# ACCESSIBILITY PLAN REVIEW

**Battery Park Senior Apartments**

Terracon Project Number F8216301

Re: **ACCESSIBILITY PLAN REVIEW REPORT**  
**Battery Park Senior Apartments**  
1 Battle Square  
Asheville, North Carolina 28801  
NCHFA Project Number TBD  
Terracon Project Number F8216301

## #6 - Basement Storage: Door

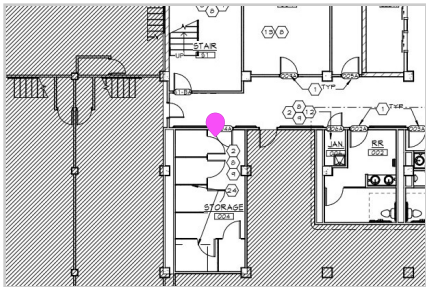
Katie Rich	Issue: There does not appear to be 18" of clearance past the latch on the pull side of the door. Please review.	25 Mar 08:58 AM
------------	---	-----------------

## #12 - Trash Chute 13th Floor: Maneuvering Clearance

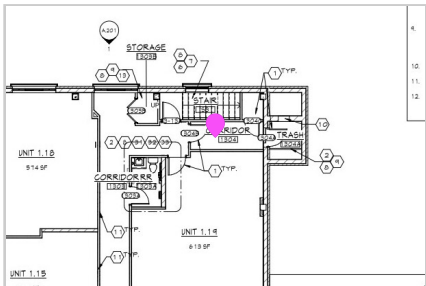
Katie Rich	Issue: There does not appear to be adequate maneuvering clearance to access the trash chute on the 13th Floor (other floors are similar). In addition, there does not appear to be 18" of clearance past the latch on the pull side of the door. Please review.	28 Mar 03:42 PM
------------	---	-----------------

#18 - Mail Area: Maneuvering Clearance

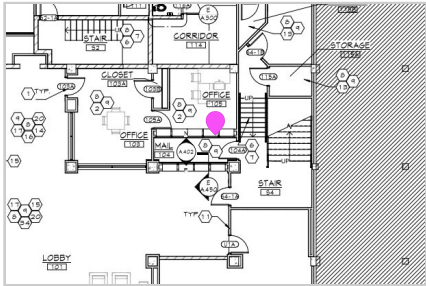
Issue: There does not appear to be adequate maneuvering clearance to access the mail area. In addition, there does not appear to be 18" of clearance past the latch on the pull side of the door. Please review.

Per NCHFA, mail kiosks require 60" minimum clear floor space and with mailbox locks centered on a 48" minimum parallel approach. Mailboxes for all units may not exceed 48" above finish floor.

## #16 - Parking Counts

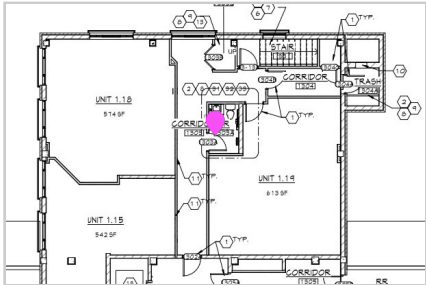
Issue: The accessible parking counts are not provided in the drawings. Please provide. In addition, the number of required accessible parking spaces does not appear to be provided. Please clarify.

● **#14 - 13th Floor Restroom: Clearance**

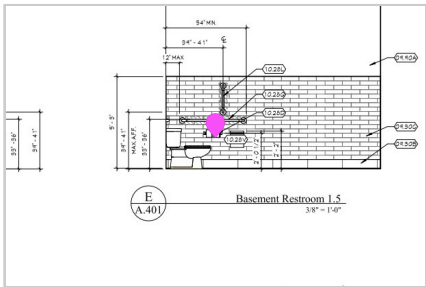
Issue: A minimum of one accessible restroom should be provided on the 13th Floor. Both restrooms appear to be confined between corridors or dwelling units. Provide an accessible bathroom with compliant maneuvering clearances.

● **#8 - Common Area & Mobility Restrooms: Toilet Paper**

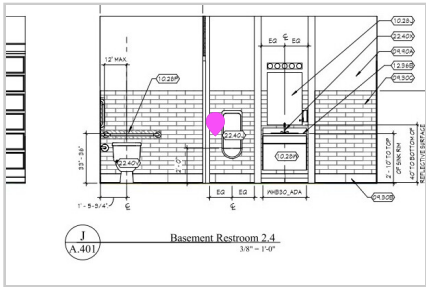
Issue: The toilet paper dispenser should be located 7" to 9" forward from the lip of the toilet to the center of the dispenser. Please review all restrooms.

● **#9 - Men's Basement Restroom (003): Urinal**

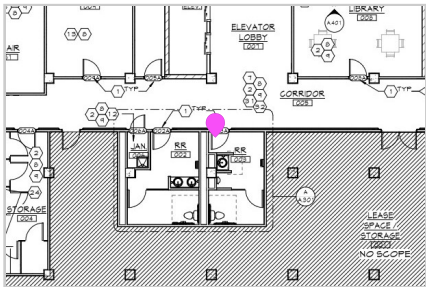
Issue: Ensure that a minimum of 30" clearance is provided to access the urinal.

● #23 - 2nd Floor Restrooms: Doors

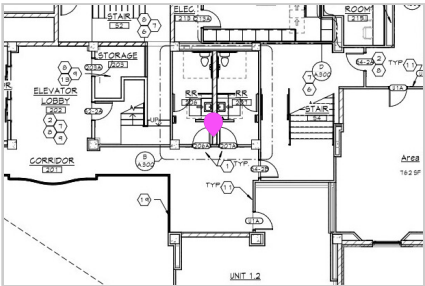
Melissa Middleton	Issue: The required door maneuvering clearance does not appear to be provided on the pull side of the door. A minimum of 48" is required between the door and opposing wall.	05 Apr 02:44 PM
-------------------	--	-----------------

● #1 - Mobility Unit: Window Controls

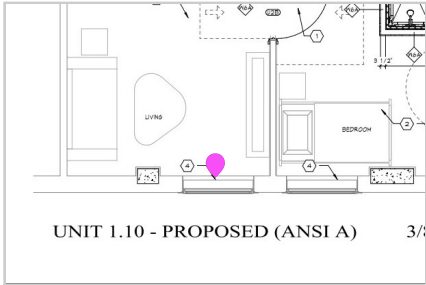
Hamid Dehghan Niri	Issue: Clarify and coordinate the window type. Operable parts should be accessible and within a reach range of 48" above finish floor in all rooms except the kitchen and bath in the designated accessible dwelling units. (No pinching, twisting and turning of the wrist to operate.)	24 Mar 06:19 PM
--------------------	--	-----------------

#19 - Mobility & Sensory Units: Emergency Pull Cord

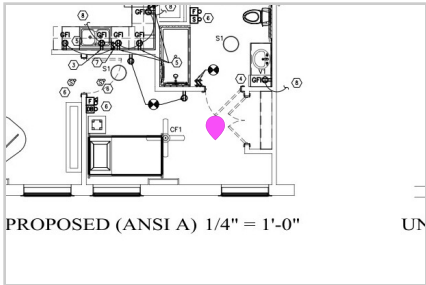
**Task messages (time in EDT)**  
Katie Rich      Issue: Emergency pull cords must be mounted no higher than 48 inches from the ground and the cord must be within 6" from the floor.      30 Mar 02:02 PM

#27 - Unit Electrical Panels

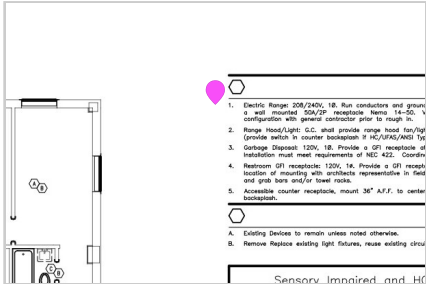
**Task messages (time in EDT)**  
Melissa Middleton      Issue: Per NCHFA, electrical panels in Type A and Type B units must be mounted at 48" maximum above finish floor to top breaker.      05 Apr 03:20 PM

#28 - Mobility Unit: Refrigerator

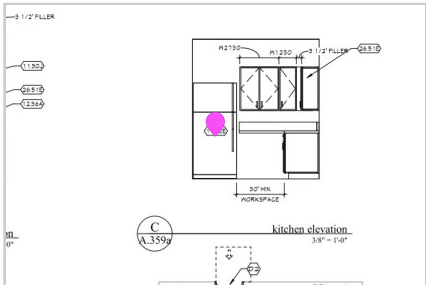
**Task messages (time in EDT)**  
Melissa Middleton      Issue: Per NCHFA, all accessible "Type A" units must have a side by side refrigerator or one with a bottom freezer drawer. The refrigerator doors must be able to open enough for storage bin removal.      05 Apr 03:24 PM

#29 - Mobility Unit: Cabinet Hardware

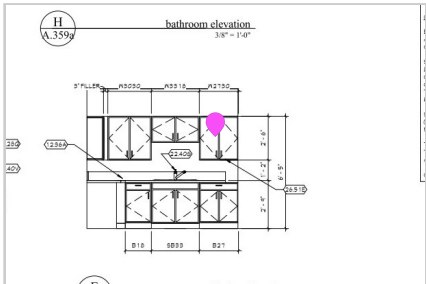
**Task messages (time in EDT)**  
Melissa Middleton      Per NCHFA for elderly properties, loop handles is required on all cabinets and drawers.      05 Apr 03:35 PM

### ● #30 - Unit Identification

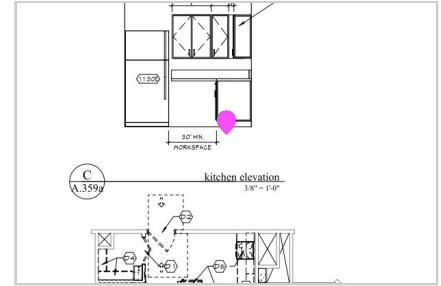
Melissa Middleton	Issue: Identify the locations of the dwelling units for the mobility impaired and for the dwelling units that will have the audio-visual equipment to be provided for the sensory impaired.	05 Apr 03:44 PM
-------------------	---	-----------------

## ● #4 - Mobility Unit 1.10: Kitchen Work Surface

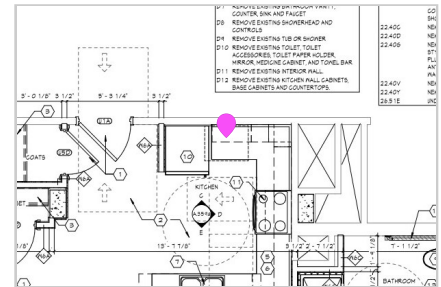
Katie Rich	Issue: We recommend that the work surface be located adjacent to the range/oven. Per NCHFA, the switches for the range hood and light are to be located behind the work station which per the electrical plan is located to the right of the range. Coordinate the work surface area and the switches.	25 Mar 08:48 AM
------------	--	-----------------

## ● #7 - Mobility Unit 1.10: Range Controls

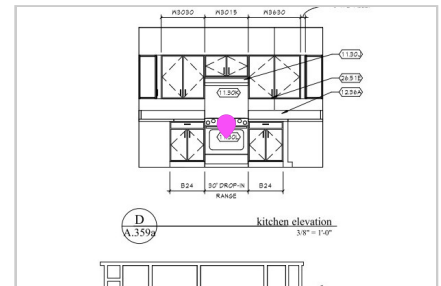
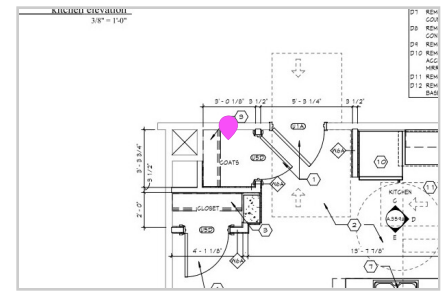
Katie Rich	Issue: Mobility units must have controls located on the front of range. It is recommended that the same range type (11.30C) used in mobility Unit 2.4a is used in Unit 1.10.	25 Mar 09:49 AM
------------	--	-----------------

## ● #15 - Mobility Unit 1.10: Door

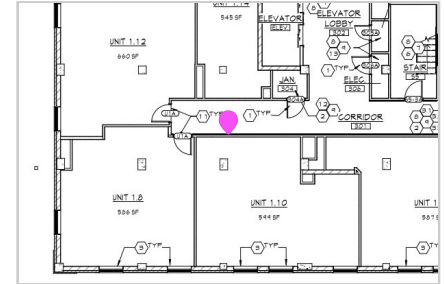
Katie Rich Issue: There is no door provided on the floor plans for this unit. 28 Mar 04:08 PM

## ● #20 - First Floor Door 109B (Door S1-1B Similar)

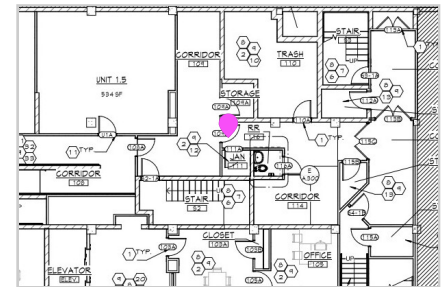
Katie Rich Issue: There does not appear to be 18" past the latch on the pull side of the door. Please review. 30 Mar 02:04 PM

## ● #24 - Mobility Unit 2.4a: Kitchen Work Surface

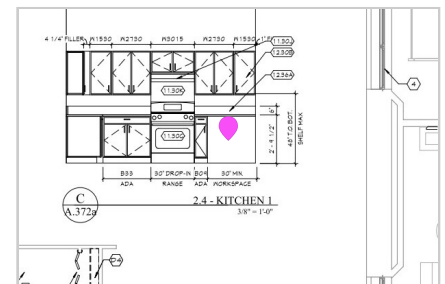
Melissa Middleton Issue: We recommend that the work surface be located directly adjacent to the range/oven. 05 Apr 02:59 PM

● **#25 - Mobility Unit 2.4a: Range Hood Switches**  
Plan Review | Melissa Middleton | Unit-Mobility  
Plan: E.309 - ELECTRICAL DWELLING UNIT PLANS | Location: UNIT 2.4

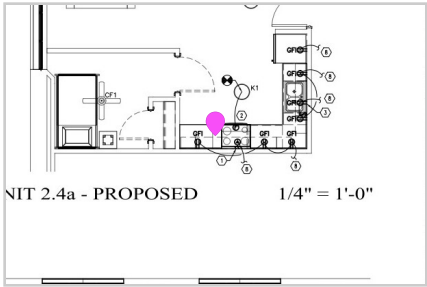
Melissa Middleton	Issue: The hood fan and light controls were not observed in the electrical plans. The controls should be located within the reach range and behind the work surface.	05 Apr 03:06 PM
-------------------	--	-----------------
